Re: Application for improvement permit for: 6 Bedroom House
Property Location: 14122 Lancaster Hwy, Pineville, NC 28134 (PID 223-266-29)
Health Department File Number: **9562B (App ID 8512)**

Sheet: 1 of 2
Property ID: 223-266-29
Lot #: NA
File #: 9562B
AppID: 8512

SOIL/SITE EVALUATION for ON-SITE WASTEWATER SYSTEM

Sketch of Soil Evaluation Locations

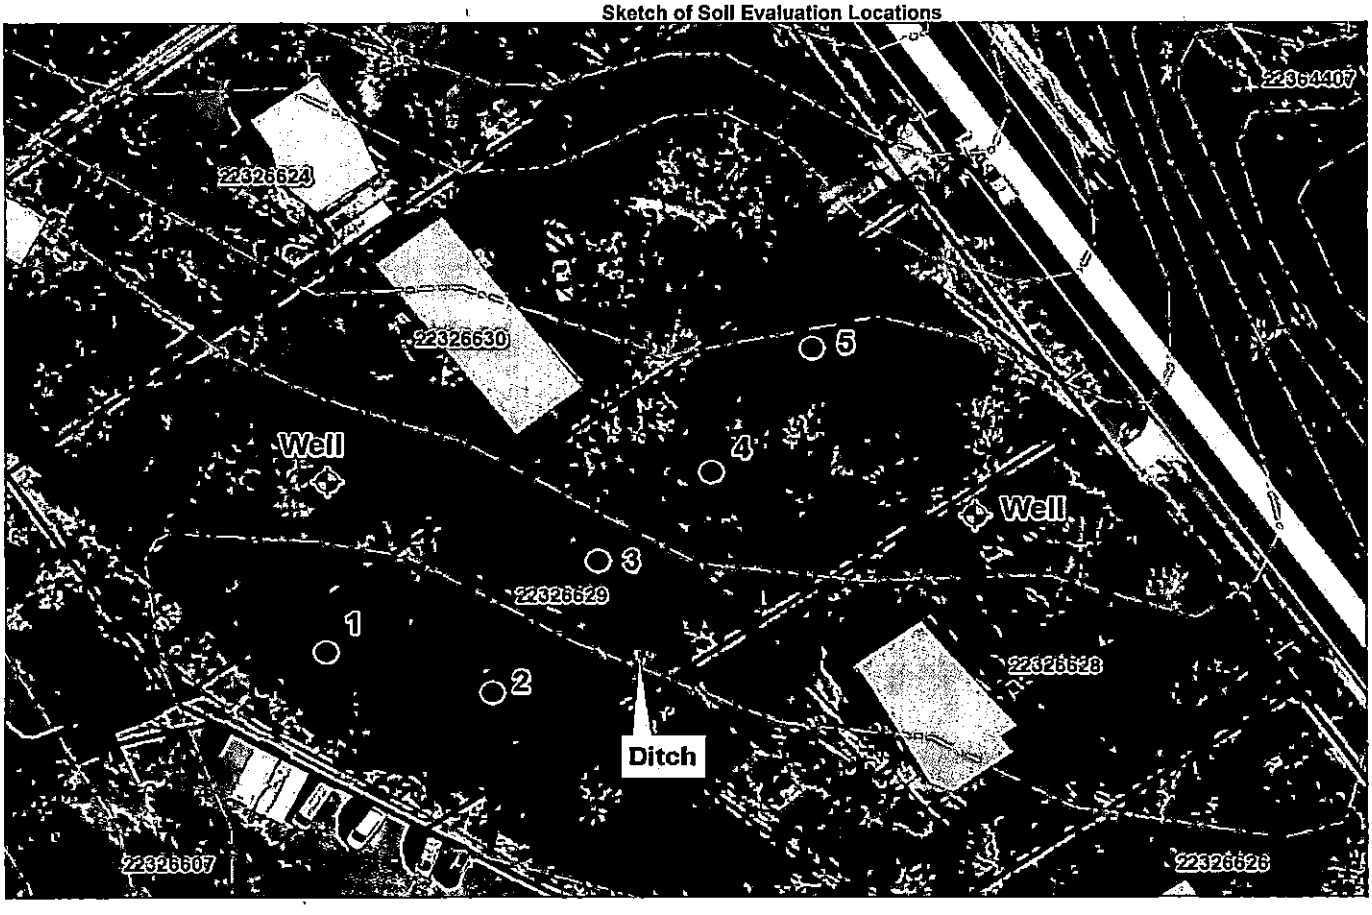
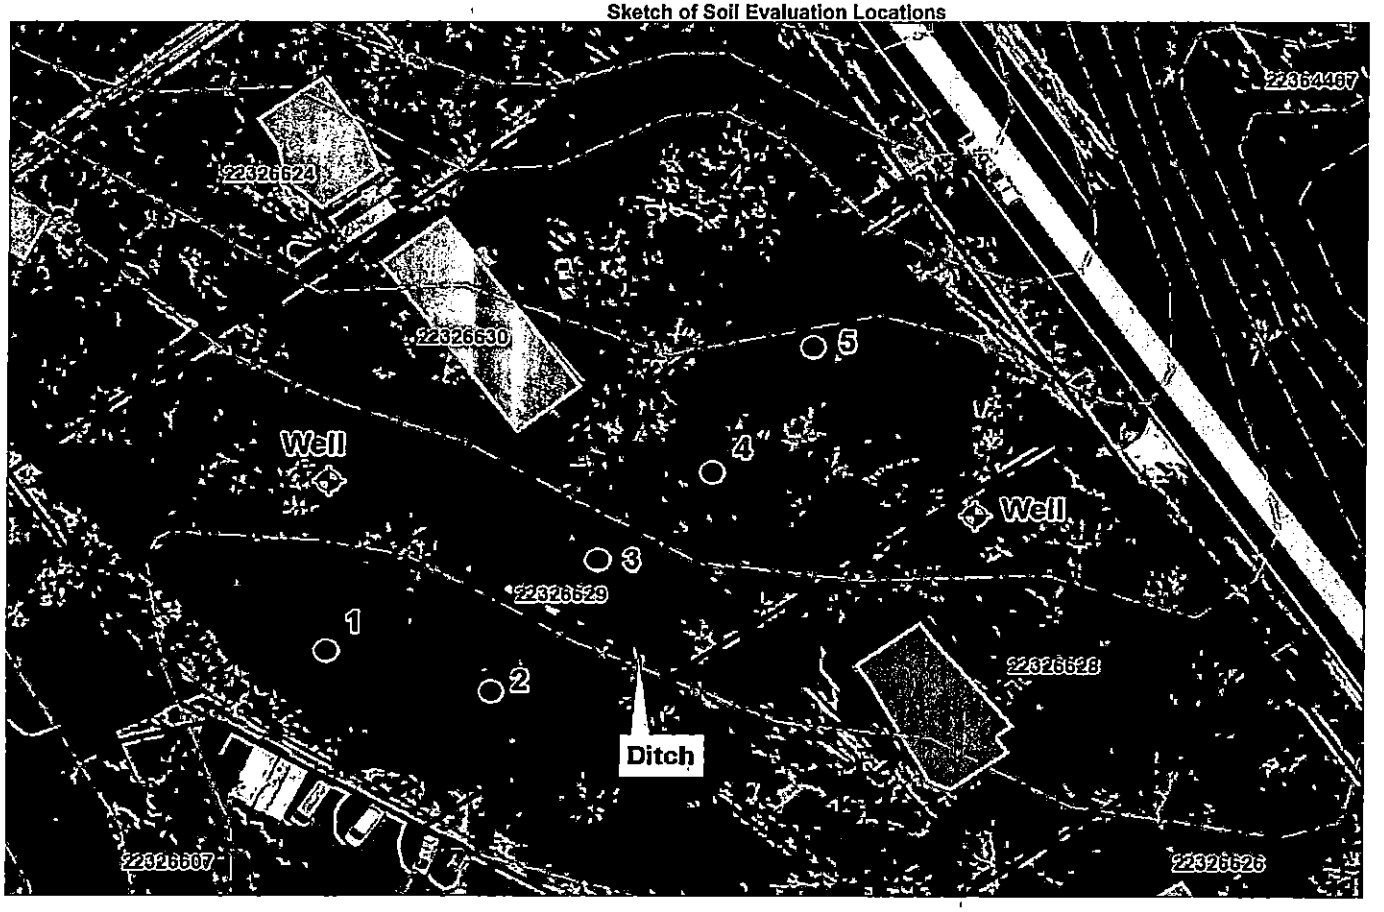
Based on the criteria set out in Title 15A, Subchapter 18A, of the North Carolina Administrative Code, Rules .1940 through .1948, the evaluation indicated that the site is **UNSUITABLE** for a ground absorption sewage system. Therefore, your request for an improvement permit is **DENIED.** A copy of the site evaluation is enclosed. The site is unsuitable based on the following:

- ☐ Unsuitable soil topography and/or landscape position (Rule .1940)
- ☒ Unsuitable soil characteristics (structure or clay mineralogy) (Rule .1941)
- ☒ Unsuitable soil wetness condition (Rule .1942)
- ☒ Unsuitable soil depth (Rule .1943)
- ☐ Presence of restrictive horizon (Rule .1944)
- ☒ Insufficient space for septic system and repair area (Rule .1945)
- ☐ Unsuitable for meeting required setbacks (Rule .1950)
- ☐ Other (Rule .1946)

Other Factors (.1946): NA
Soil Evaluation By: Jacob Presley, LSS, REHS
Others Present:
Site Classification (.1948): Unsuitable
Site Evaluation By: Jacob Presley, LSS, REHS
Others Present:

However, the site classified as **UNSUITABLE** may be classified as **PROVISIONALLY SUITABLE** if written documentation is provided that meets the requirements of Rule .1948(d). A copy of this rule is enclosed. You may hire a consultant to assist you if you wish to try to develop a plan under which your site could be reclassified as **PROVISIONALLY SUITABLE.**
